ADDITIONAL S75W AMENDMENTS 26.09.18:

**PROPOSED MIXED USE DEVELOPMENT**

47-50 THE ESPLANADE ETTALONG BEACH

AMENDED SUBMISSION			
Job no.	Drawing no.	Rev.	
J15304S2	DA 101	F

**GROUND FLOOR PLAN**

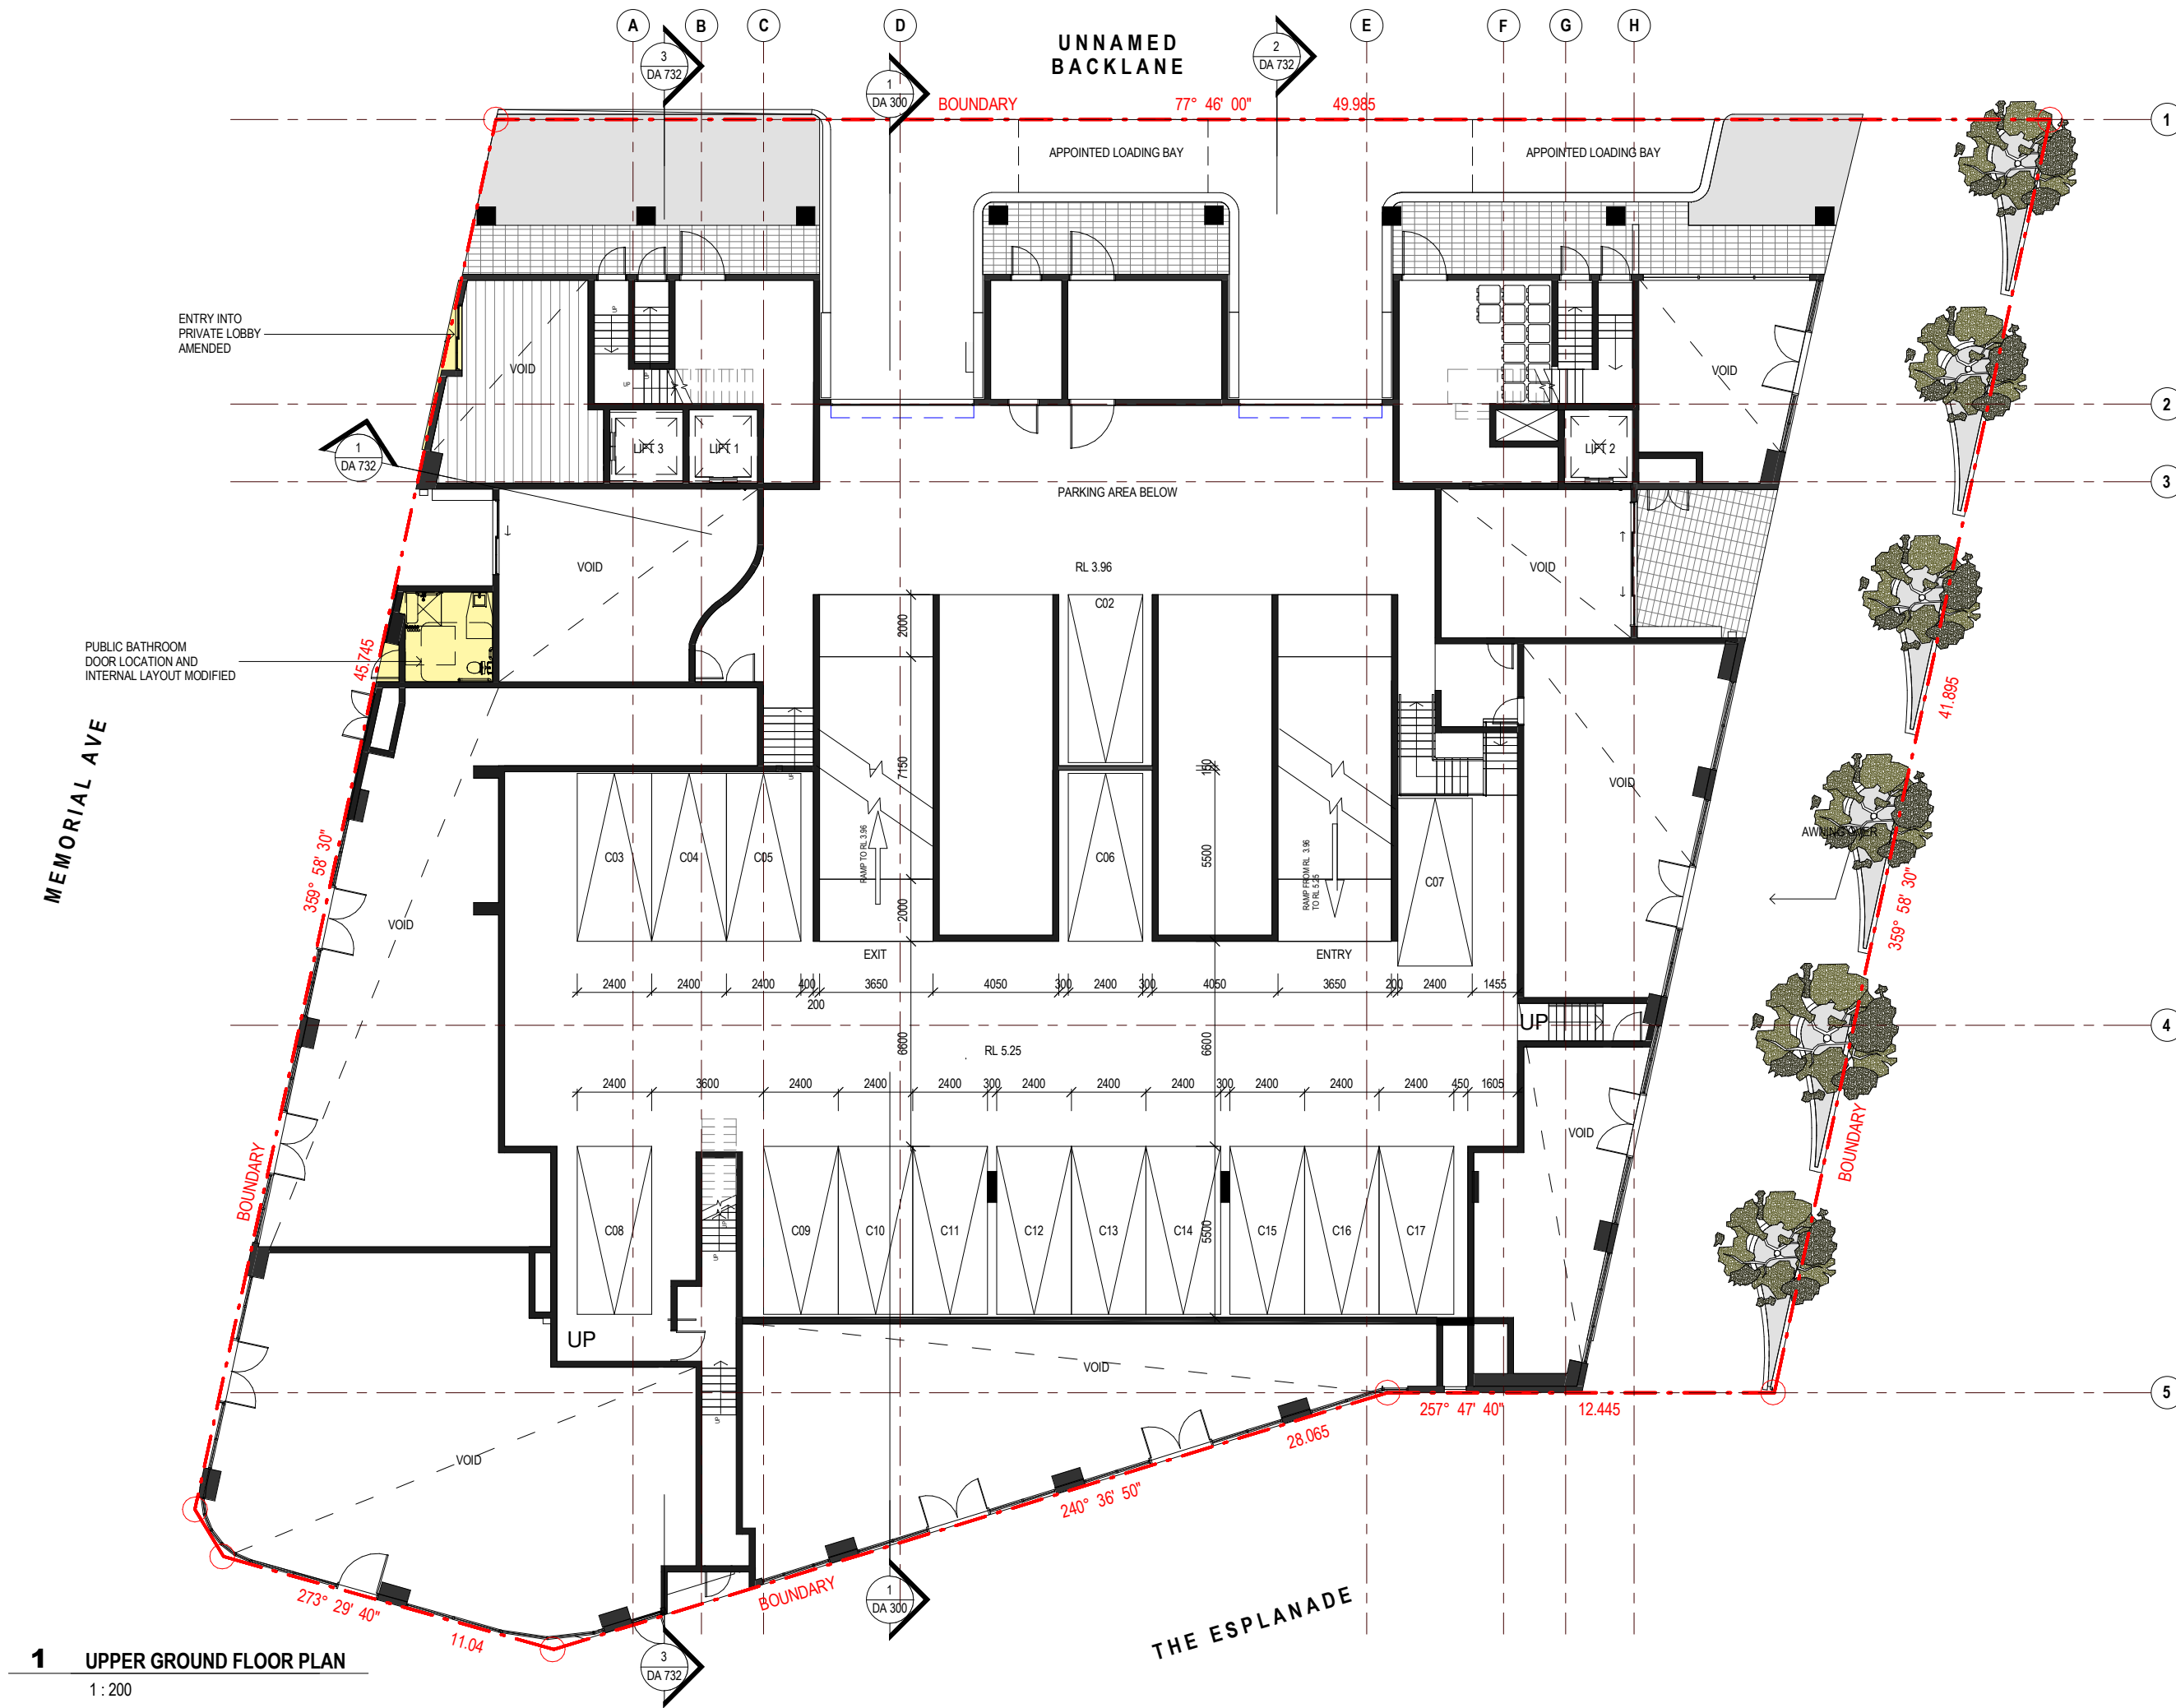
- ENTRY INTO PRIVATE LOBBY AMENDED
- PUBLIC BATHROOM DOOR LOCATION AND INTERNAL LAYOUT MODIFIED

**LEVEL 03  
FLOOR PLAN**

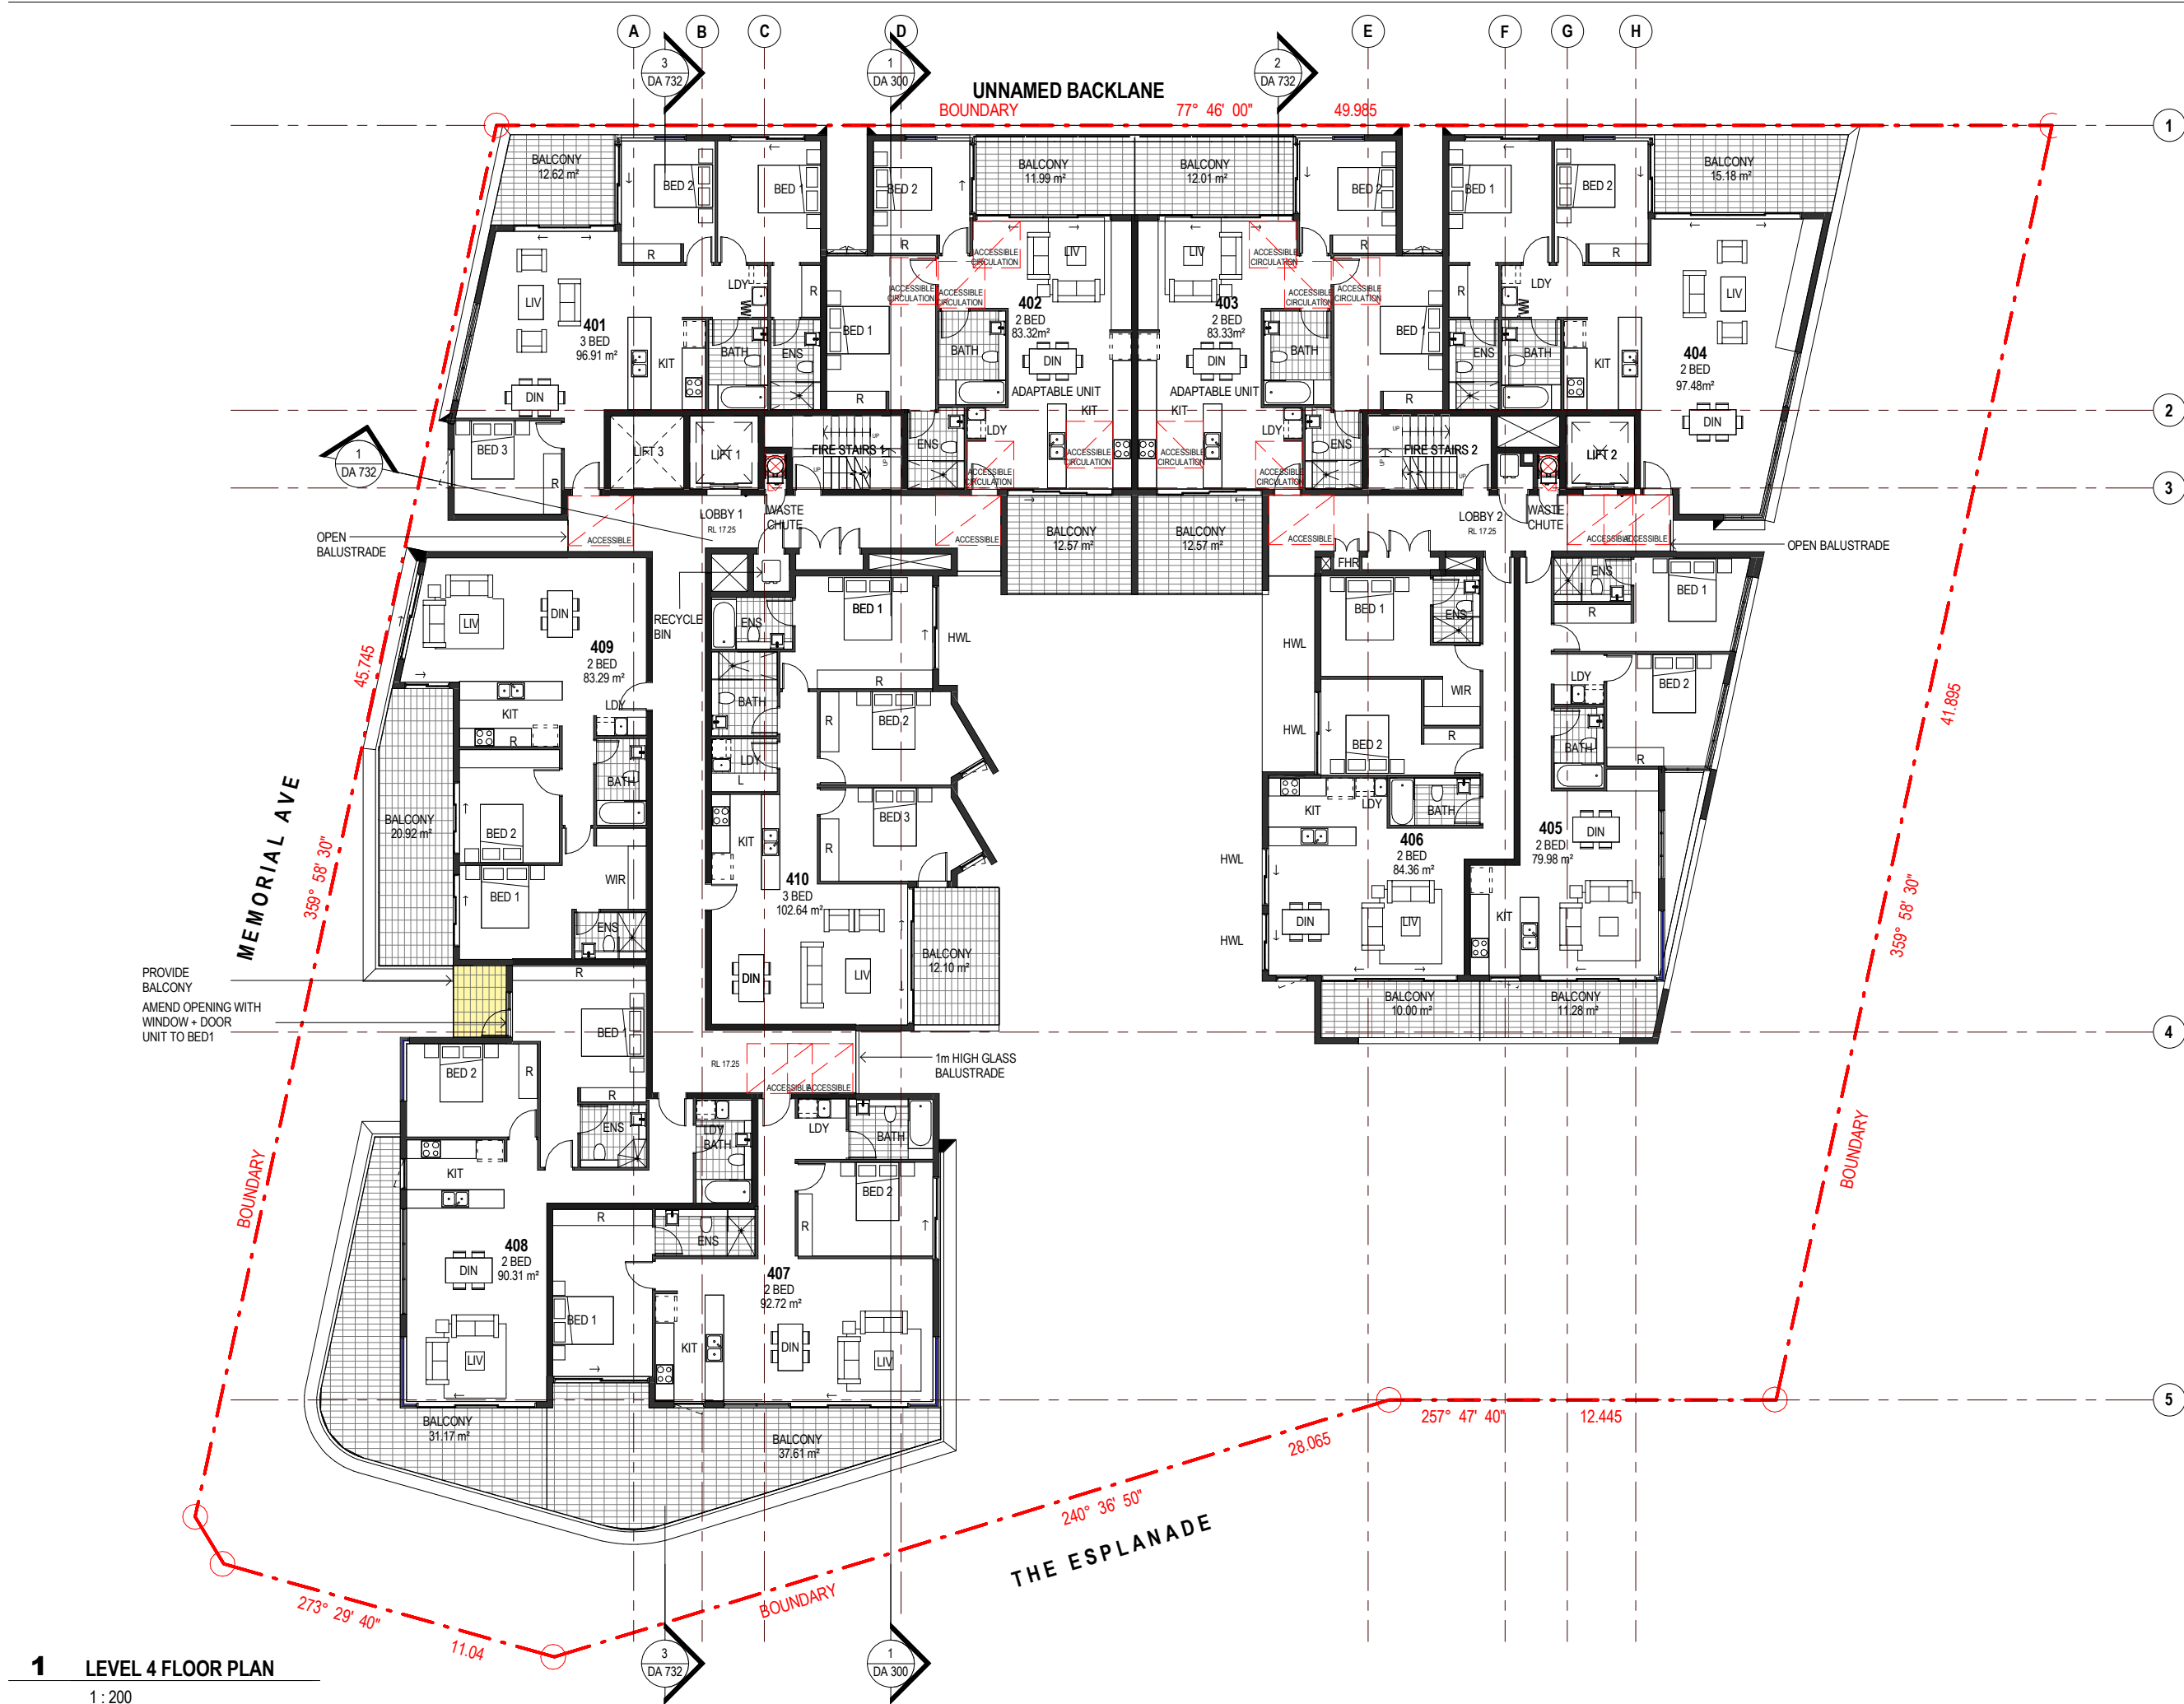
- S75W AMENDMENTS 26.09.2018:
- BALCONY TO UNITS 307 & 308 AMENDED AND INCREASED
  - LINE OF BALUSTRADES TO UNITS 307 & 308 EXTENDED
  - BALCONY TO B1 OF UNIT 308 ADDED
  - OPENING TO B1 OF UNIT 308 AMENDED

**1 LEVEL 5 FLOOR PLAN**  
1 : 200

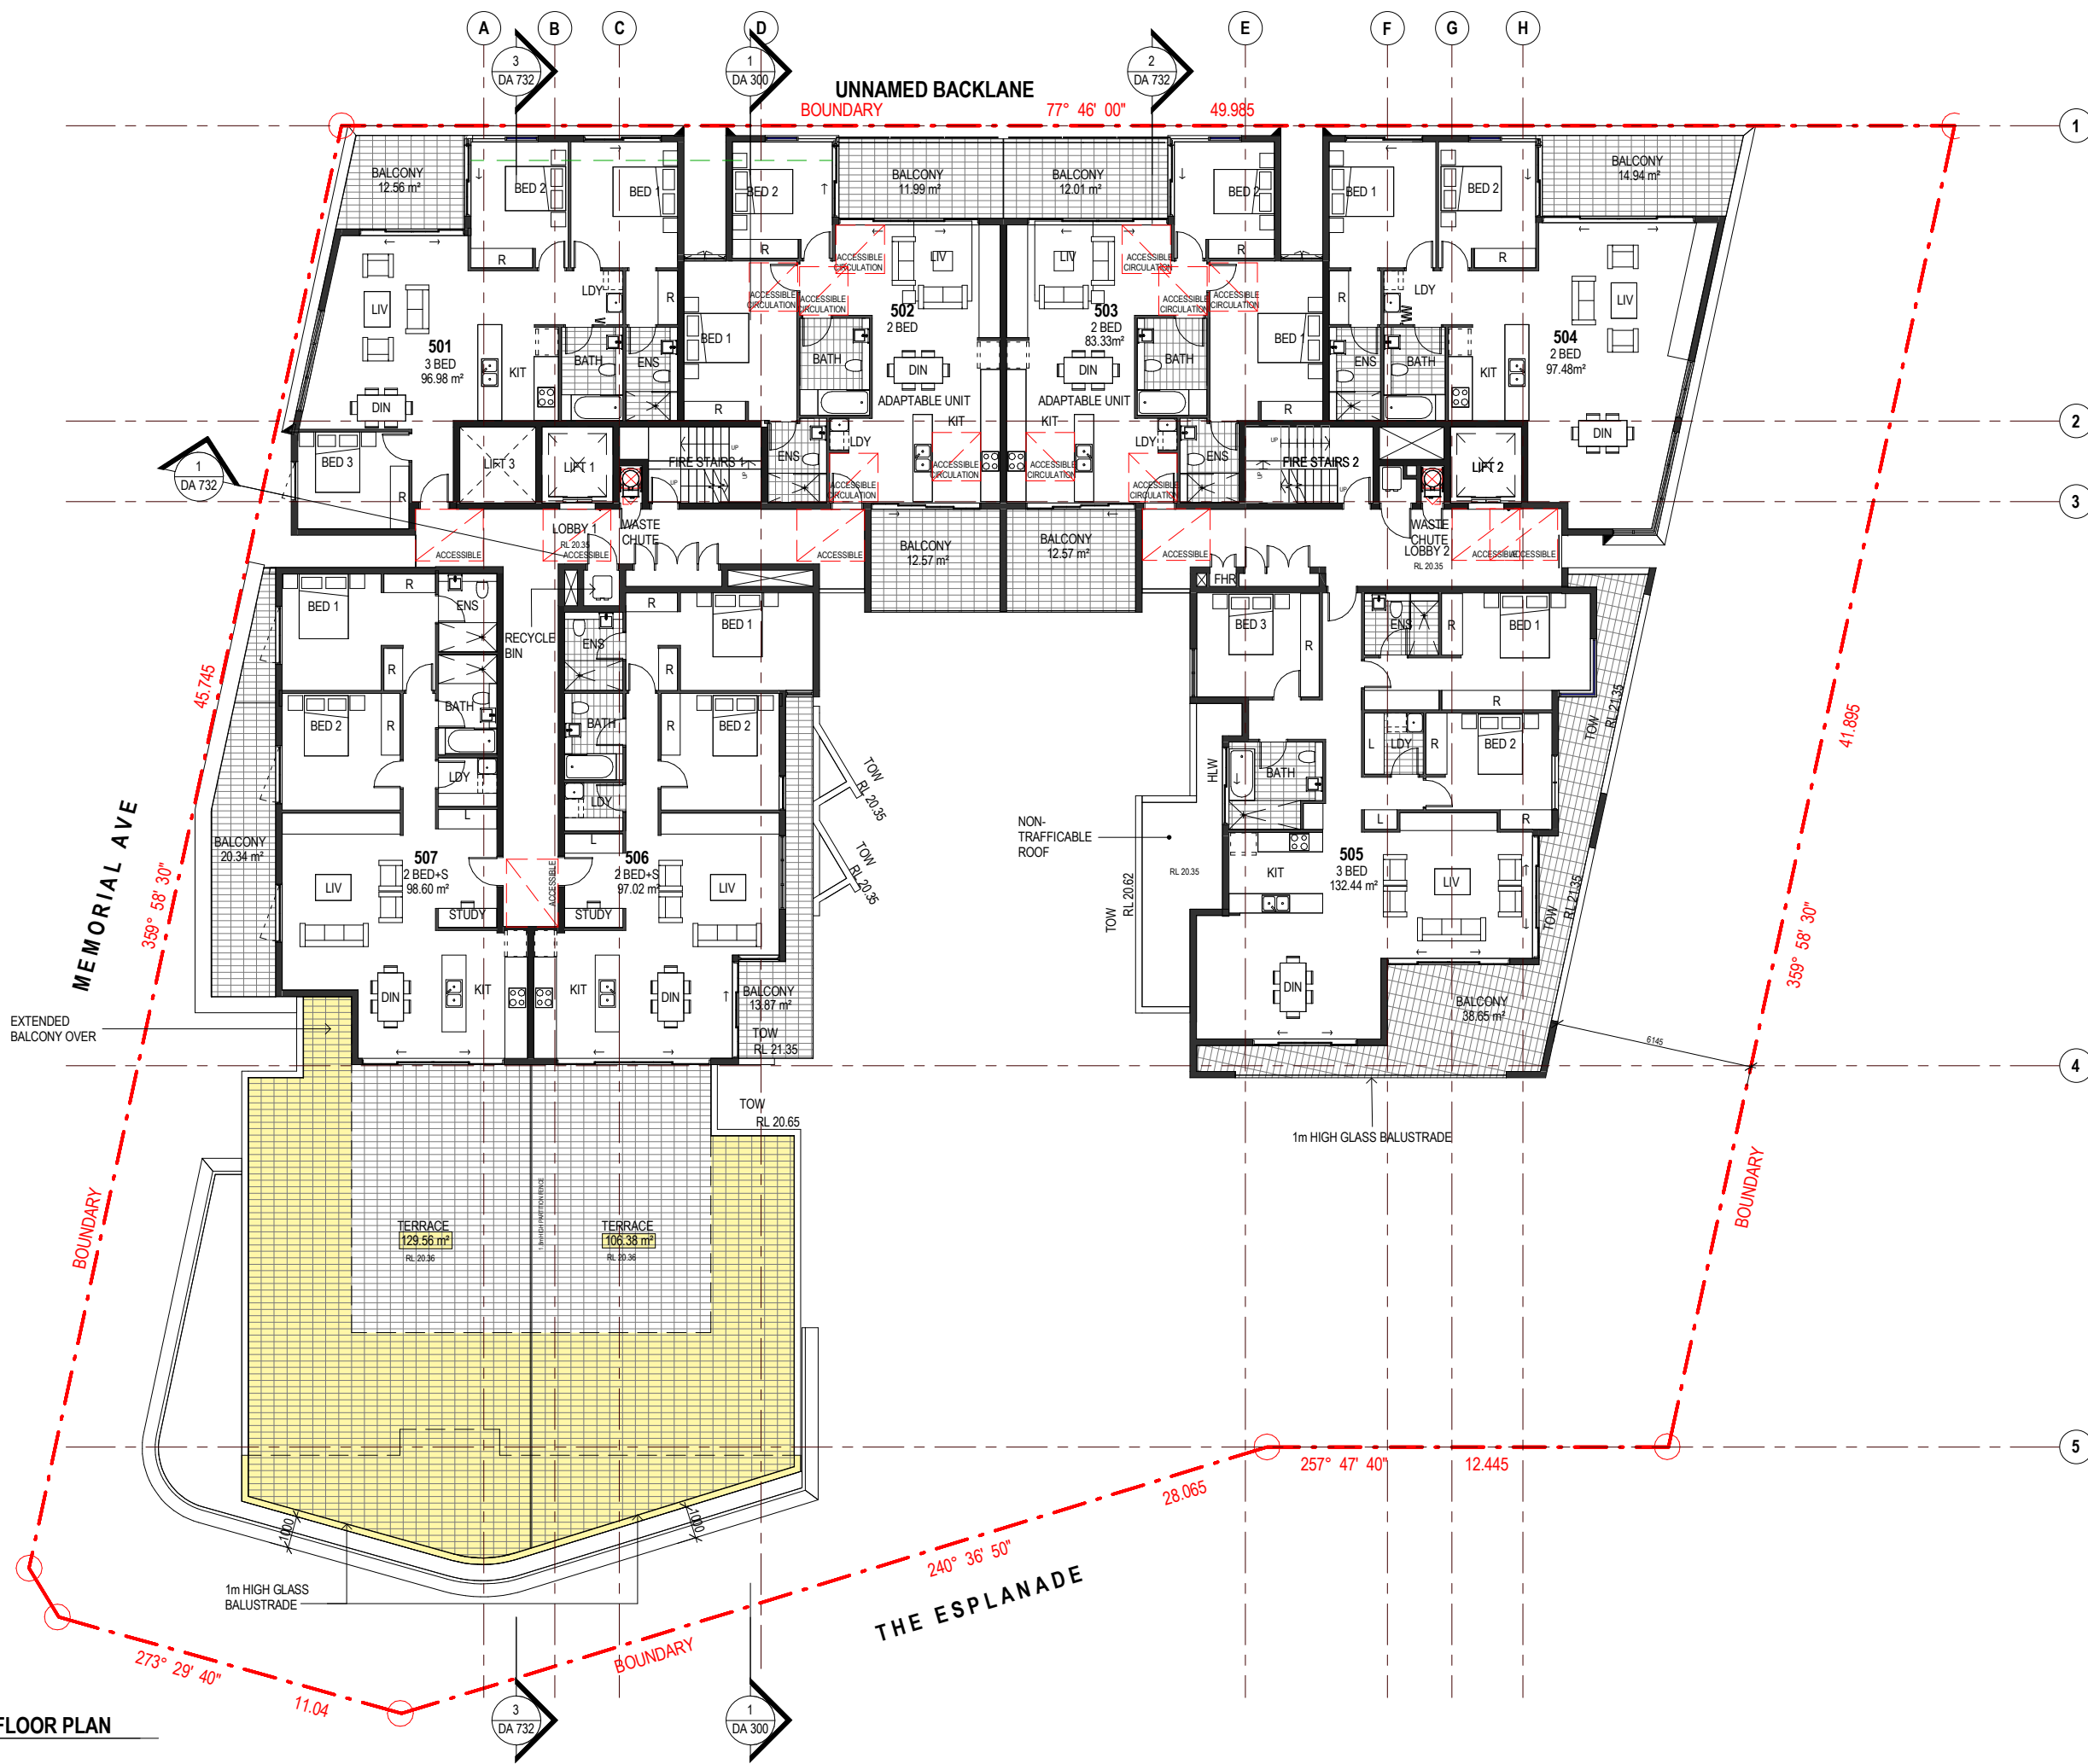
- BALCONY TO UNITS 506 & 507 AMENDED AND INCREASED
- LINE OF BALUSTRADES TO UNITS 506 & 507 EXTENDED
